SUNDRY NOTICES AND REPORTS ON WELLS
Do not use this form for proposals to drill or to re-enter an abandoned well. Use form 3160-3 (APD) for such proposals.

8. Well Name and No.
CK FEDERAL 2

WADI PETROLEUM, INC.
C&K Federal 8-2 (API# 30-015-32809)
Eddy County, New Mexico

WORKOVER PROGNOSIS

Well Bore Schematic

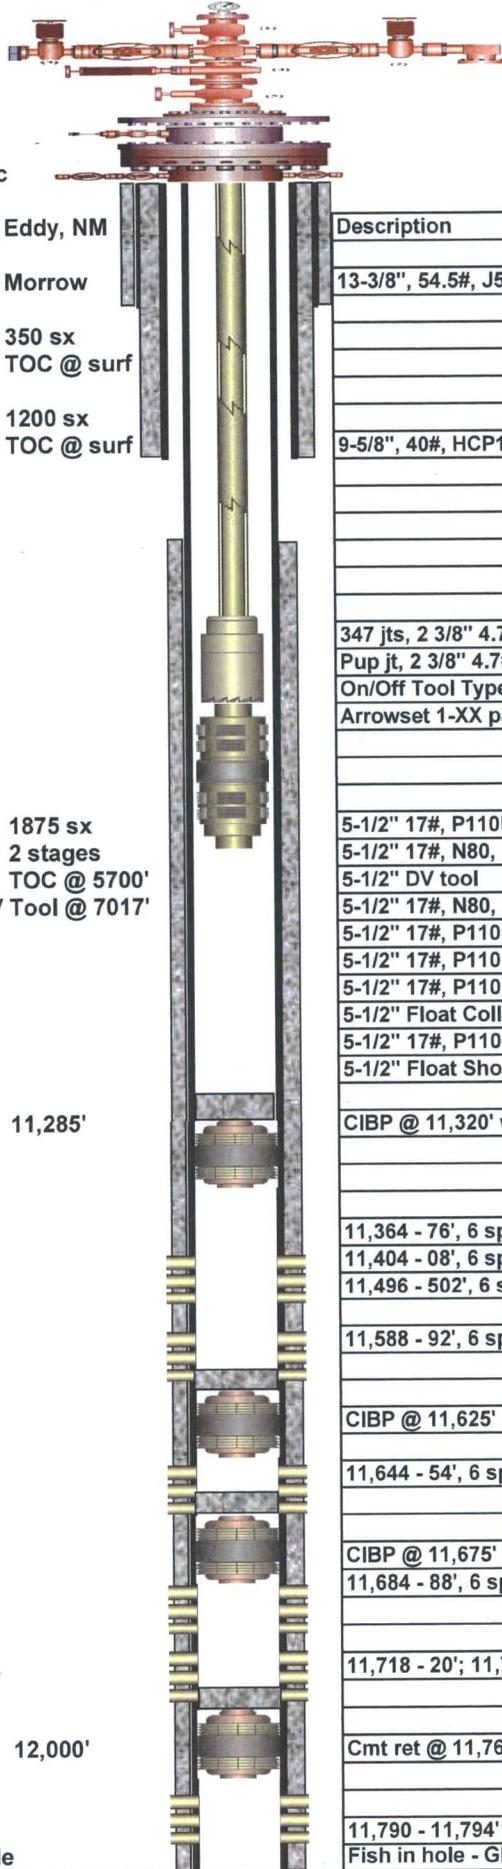
The proposed temporary abandonment procedure has been revised such that the CIBP and 35' of cement will be set by electric wireline. Attached is the revised procedure along and proposed wellbore diagram.

1. MIRU workover rig and catch tank.
2. ND tree, NU BOP.
3. Release packer, POOH, tally and stand back tbg. Send packer in for redress.
4. MIRU cased hole wireline unit. RIH w/ gauge ring-junk basket to 11,350'. RIH w/ CIBP & set @ approx. 11,320'. Dump bail 35' of cmt on top. New PBTD = 11,285'
5. MU packer on tbg, RIH to approx. 11,250'. Displace hole w/packer fluid by rev circ.
6. Close BOP on tbg and perform MIT on production casing. Perform bradenhead test by opening valves and checking for flow. Give BLM 24 hour notice prior to MIT test.
7. Set packer. ND BOP, NU tree. RDMO all equipment. File subsequent report to BLM.
